STATE OF NORTH CAROLINA  
DEPARTMENT OF TRANSPORTATION

March 24, 2023

**Subject: Request for Modification to Individual Section 404 Permit and Section 401 Water Quality Certification** for recently modified U-2579 AA (USACE, dated February 10, 2021; WQC Rev. 7, dated February 9, 2021), the Winston-Salem Northern Beltway (Eastern Section of Future I-74), from US 311 to I-40; U-2579AA; Federal Aid Project No. NHF-0918(14), Division 9. Debit \$570 from WBS No. 34839.1.7

**T.I.P. No: U-2579AA**

Jurisdictional Stream Crossing –Y1- 42+80.00 RT

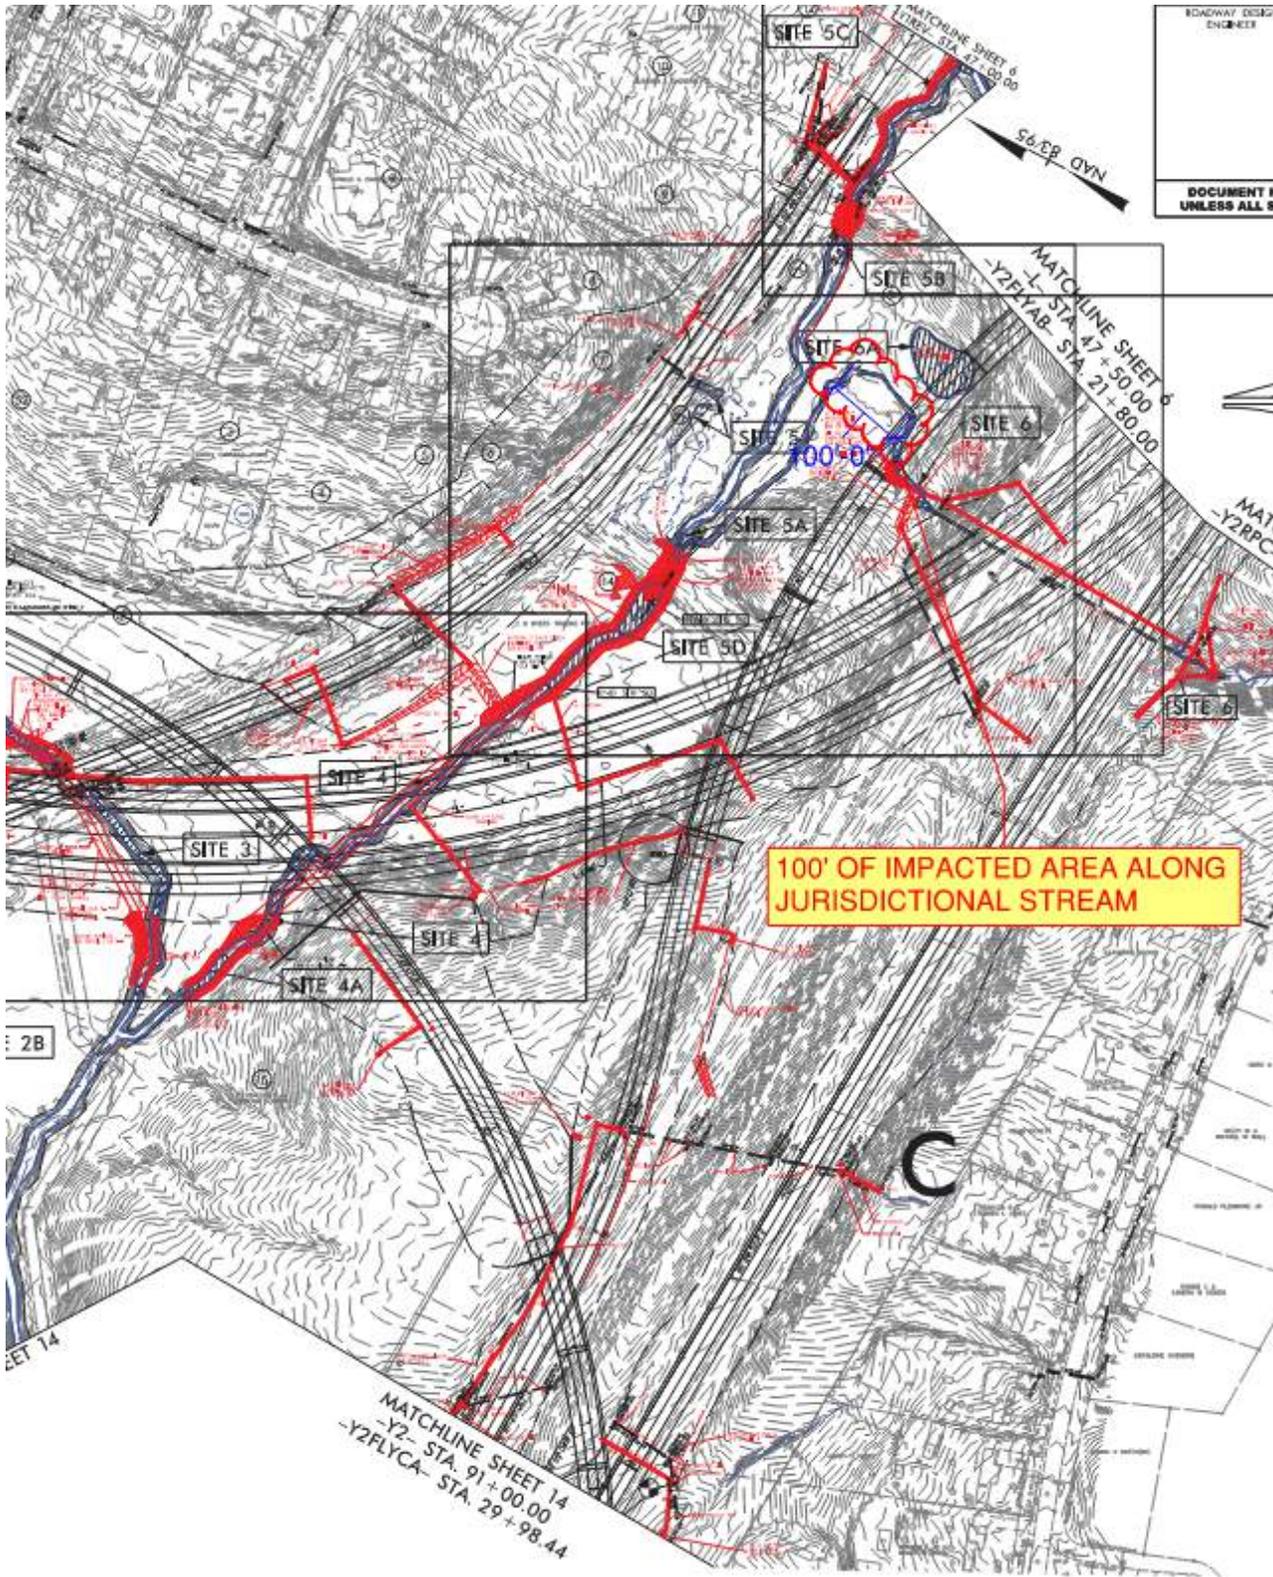
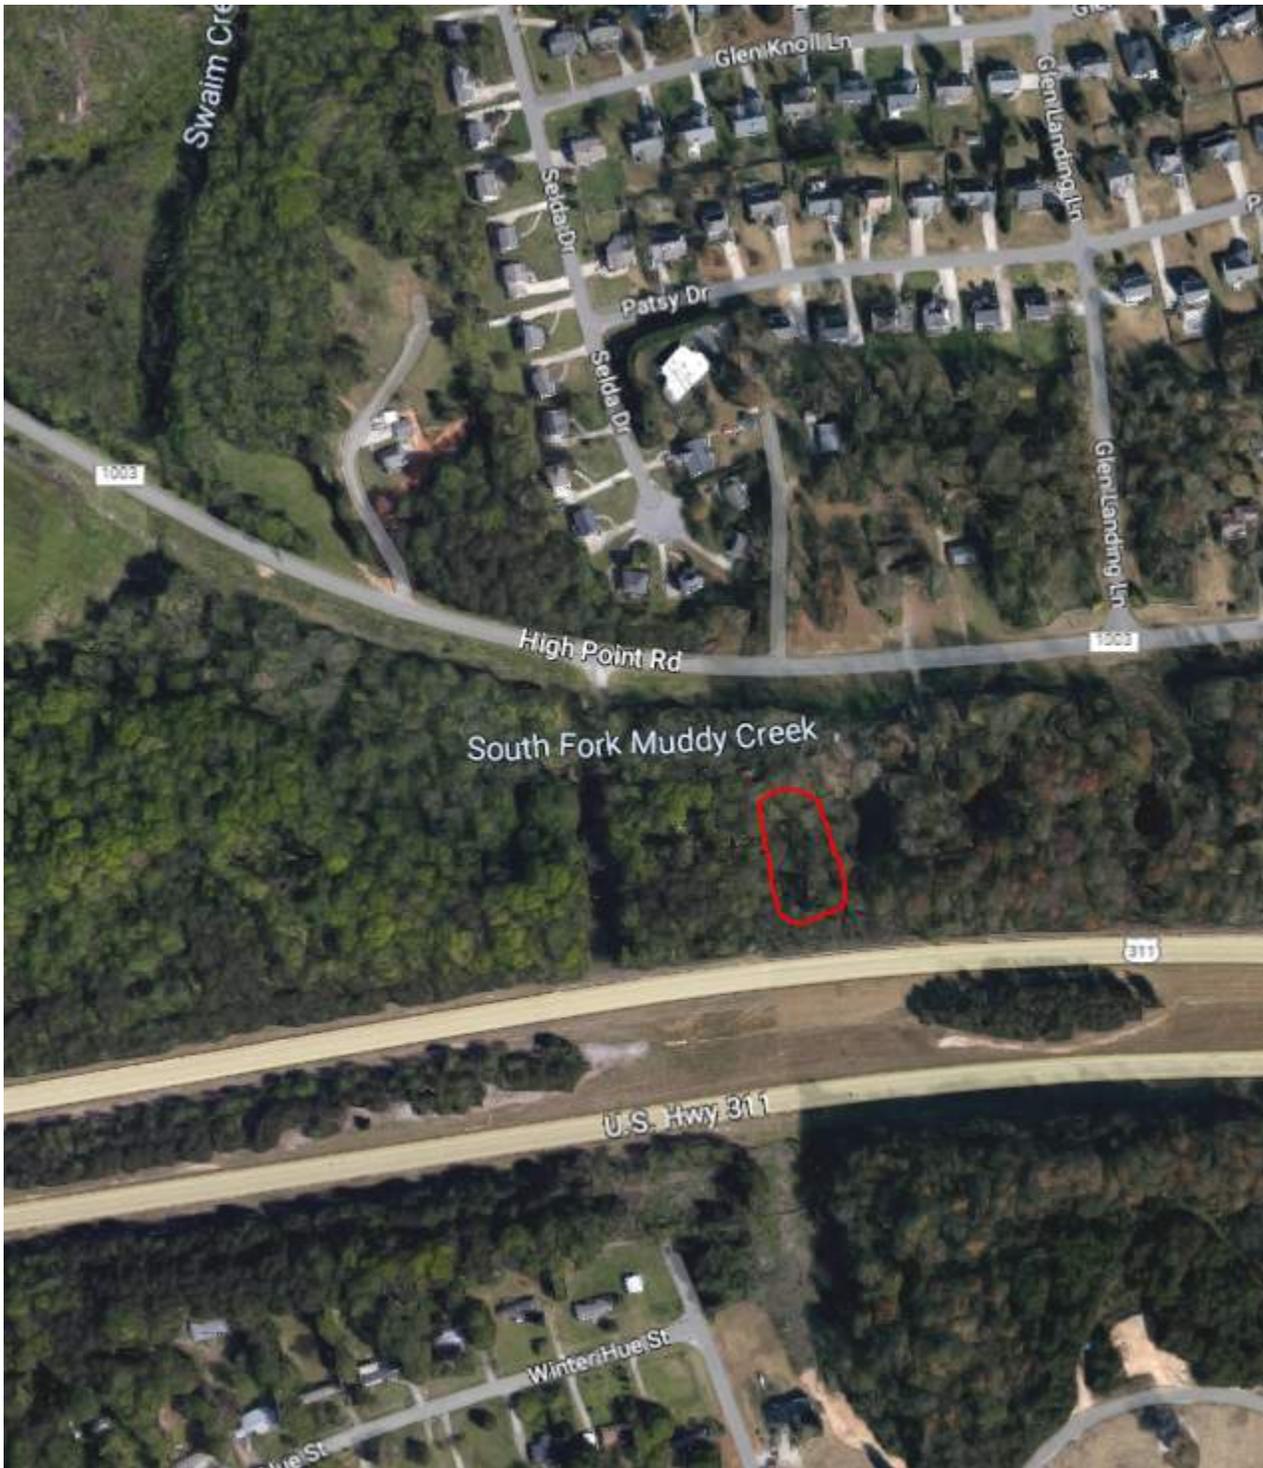
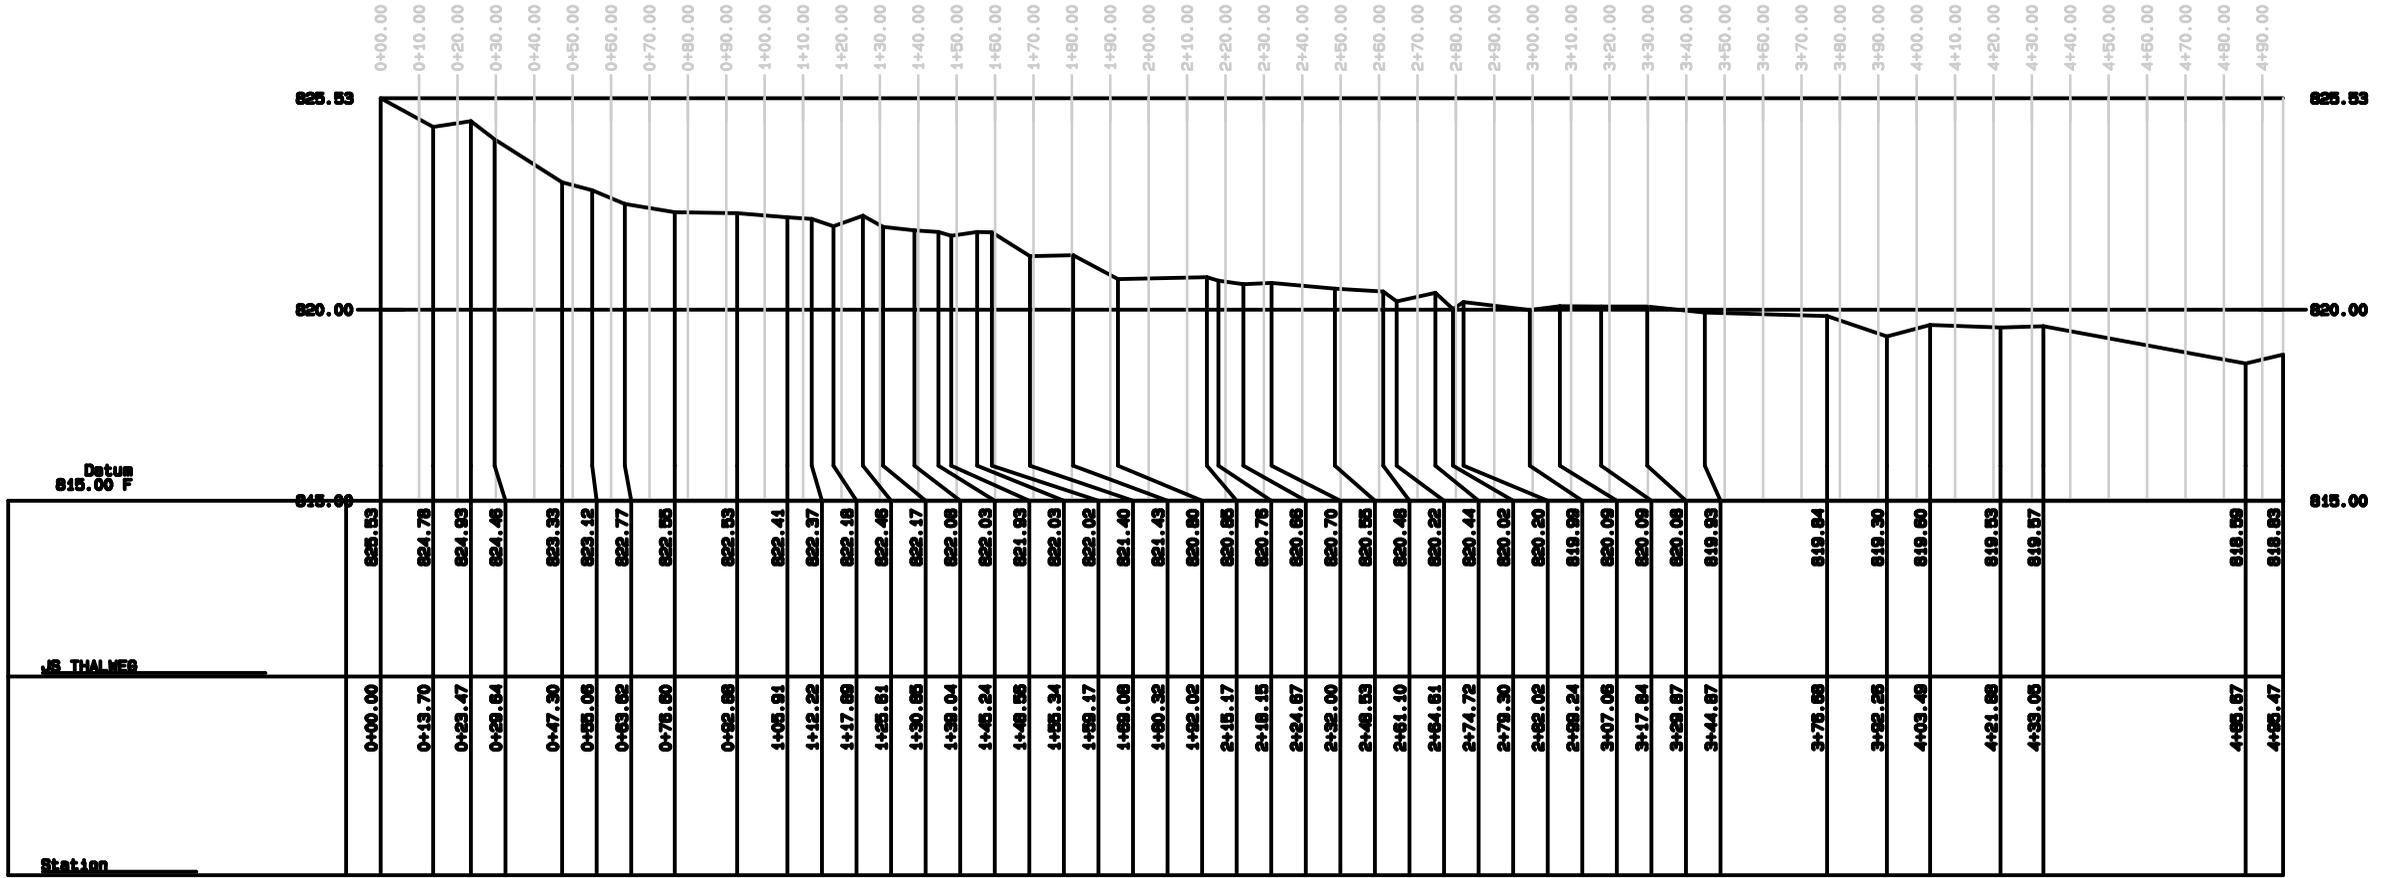
The proposed jurisdictional stream (JS) crossing is located just south of High Point Road (-Y1-) Station 42+80.00. The proposed crossing will consist of (1) 36" steel culvert pipes that have a length of 80'. The culvert pipe is the same size as the existing culvert pipe upstream of this location. The total impacted length along the JS will be 100' (approximately 10' beyond the inlet and outlet of the 80' long culvert pipe). The JS ties into the South Fork of Muddy Creek just downstream of the proposed crossing.

PERMIT DRAWING  
SHEET 4 OF 32

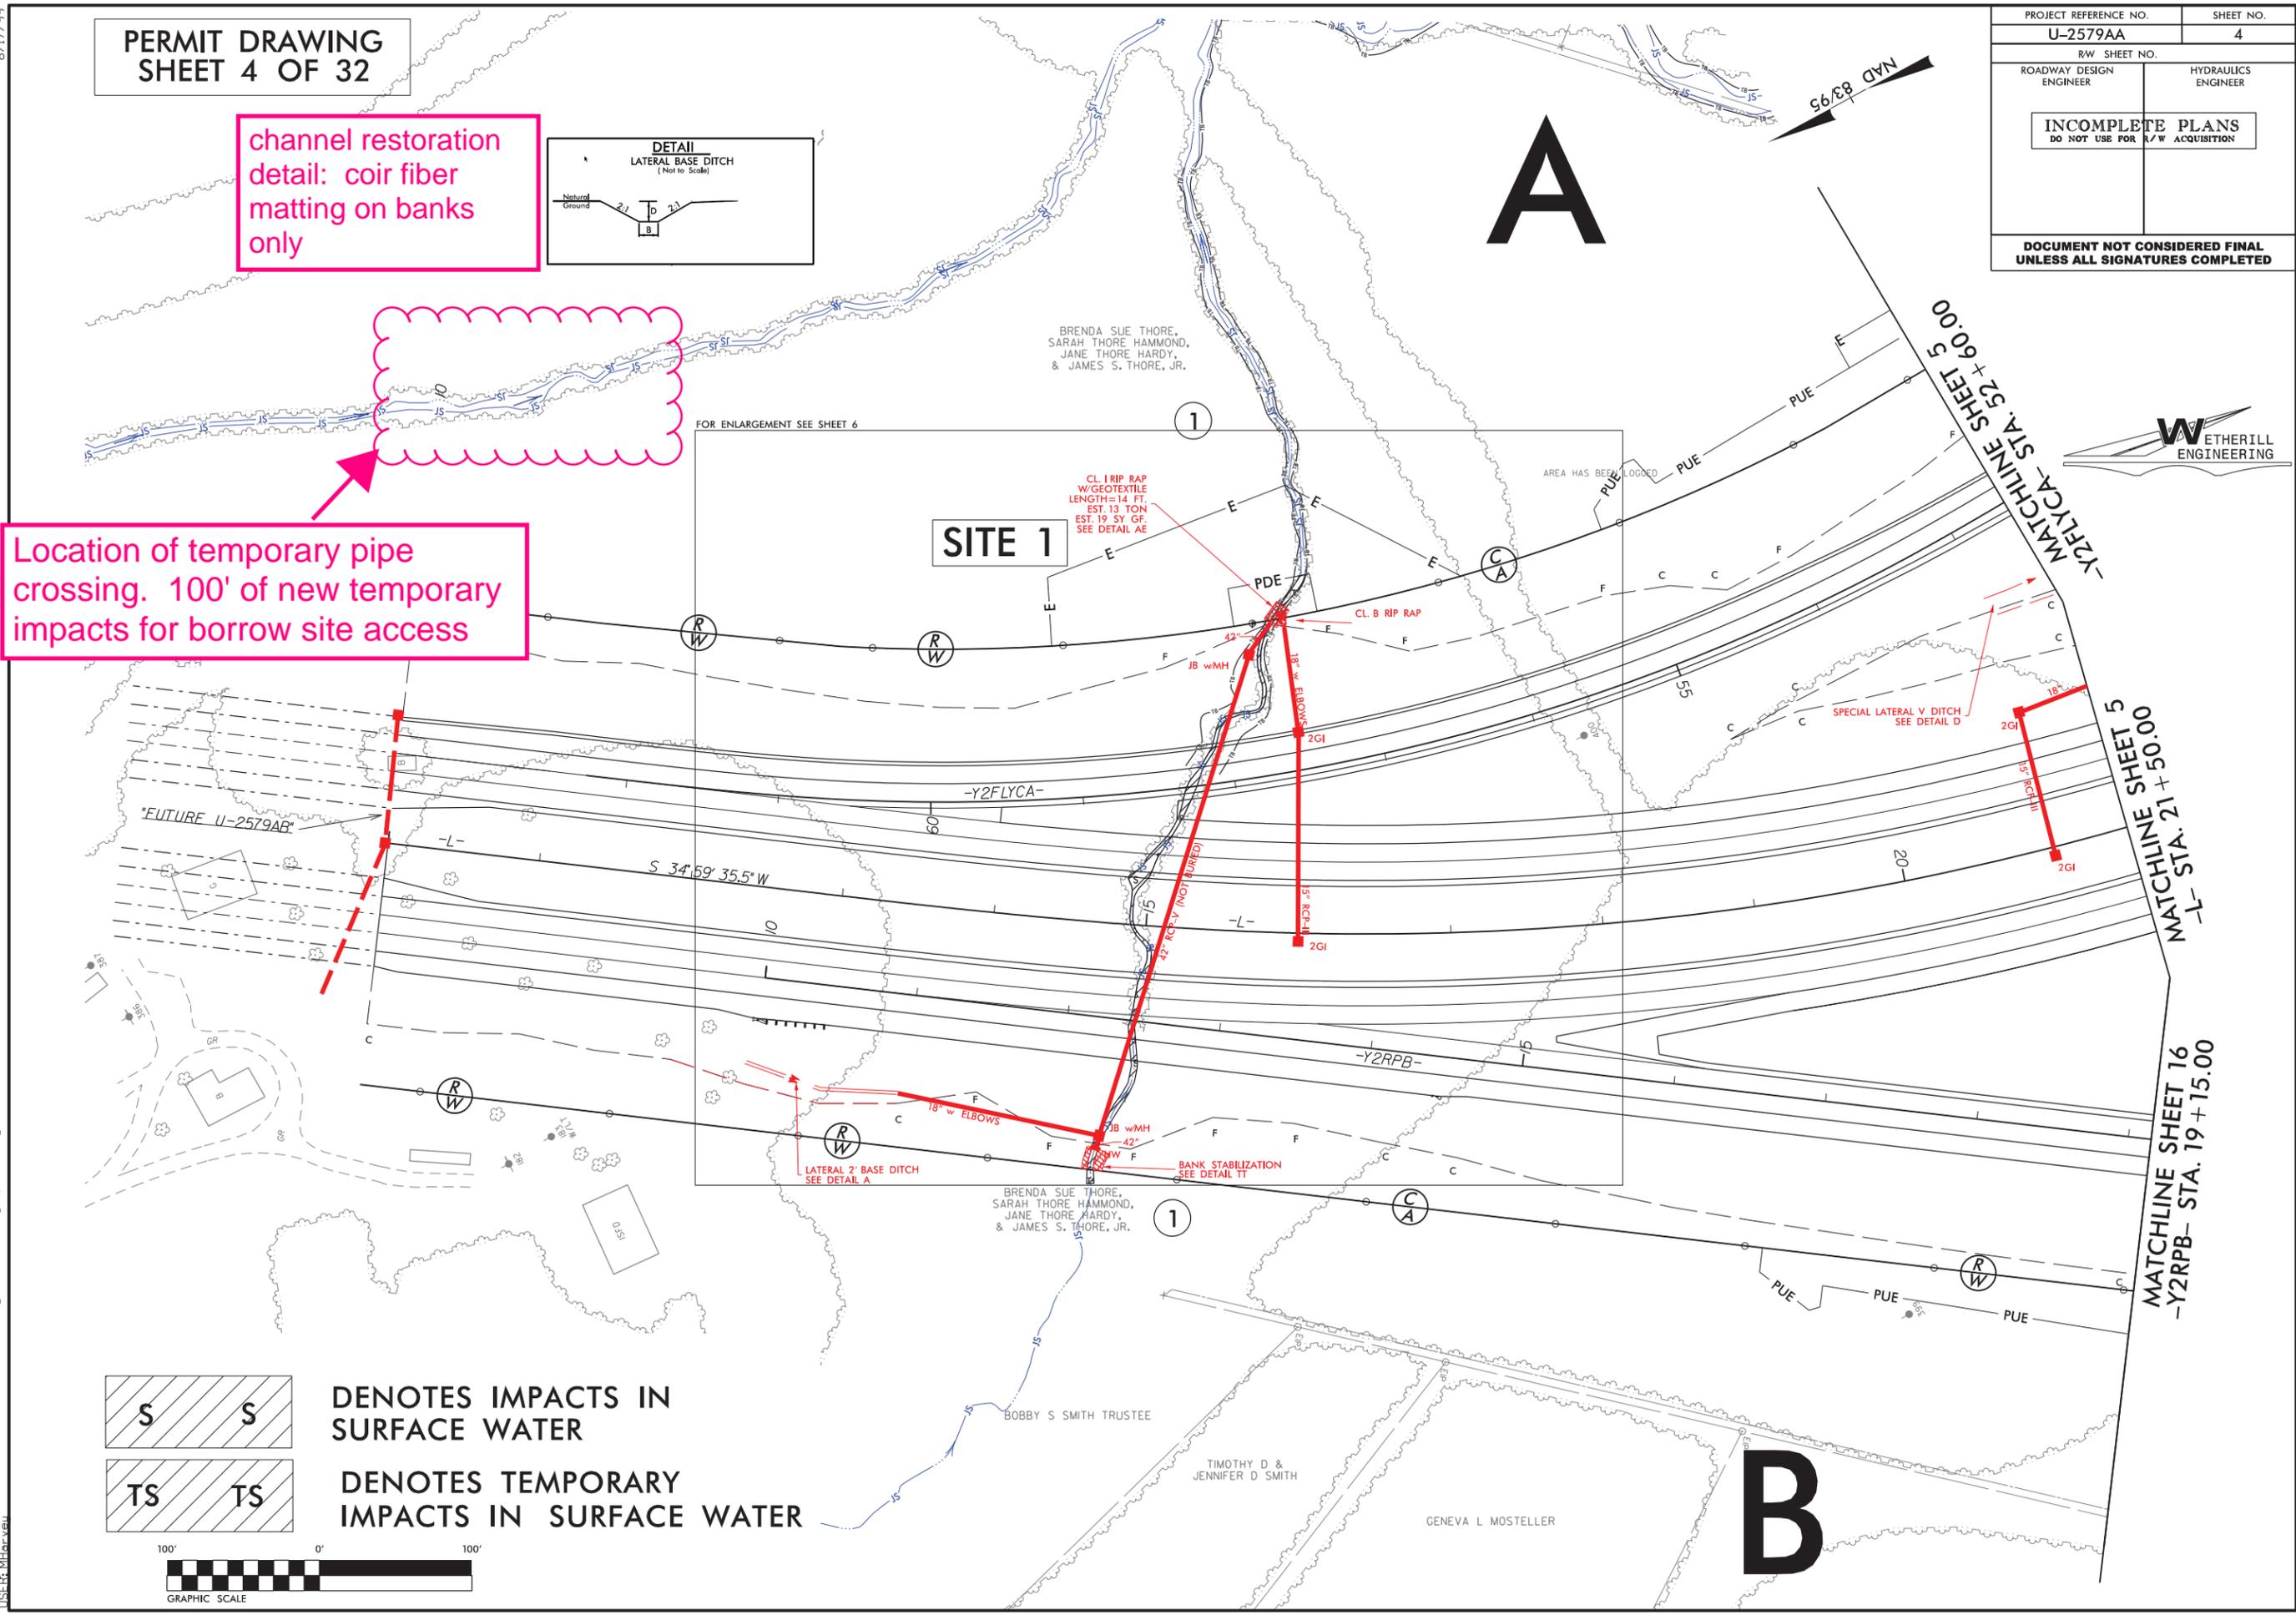
channel restoration  
detail: coir fiber  
matting on banks  
only

Location of temporary pipe  
crossing. 100' of new temporary  
impacts for borrow site access

New permit site 19: The borrow site is on NCDOT property and within the study area for the project. The stream can be seen on plan sheet 4 on the U-2579AA project, downstream of permit site 13 on the U-2579AB project. There will be 100' of temporary stream impacts to an unnamed tributary (ESE-S19 in the January 2016 PJD Report). The stream will need to be crossed to access the borrow site. A 42"X40' steel culvert will be installed in the stream and an additional 70 of

stream will be impacted for bank stabilization and/or dewatering. Once the borrow site is stabilized, the pipe and any bank stabilization will be removed and the stream will be returned to its existing alignment. The banks will be sloped at 2:1, matted with coir fiber matting and revegetated with a native riparian seed mix.
